**RC10
B6.2
TEAM KIT**

**RC10
B6.3
TEAM KIT**

RC10B6.2 vs. RC10B6.3 Comparison

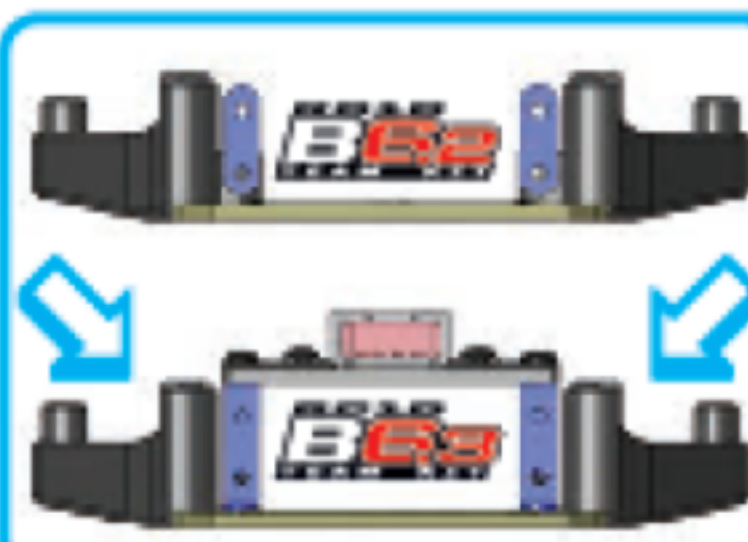
New wide pivot C arm mount

New wide pivot D arm mount

New +4mm shock rod ends included

New front shock lower and plastic cover

New rear shock lower and plastic cover

Octalock Spur and premium LCF material slipper pads (#00029 = 11mm ID, #00030 = 10mm ID)

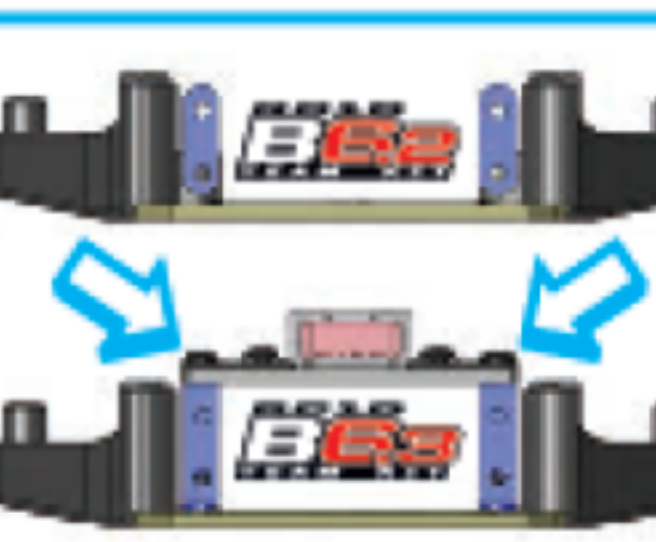
2.5mm vs 2mm thickness shock plates

Updated wing mount

New molded wire clips

Side rails updated for new servo mount

New servo mount with integrated transponder mount

New holes added to chassis for servo mount

Keyed top plate to steering bellcrank brace

New material steering linkage rod ends

Hardware for tie-rod battery brace included

Carbon fiber +1 steering plates
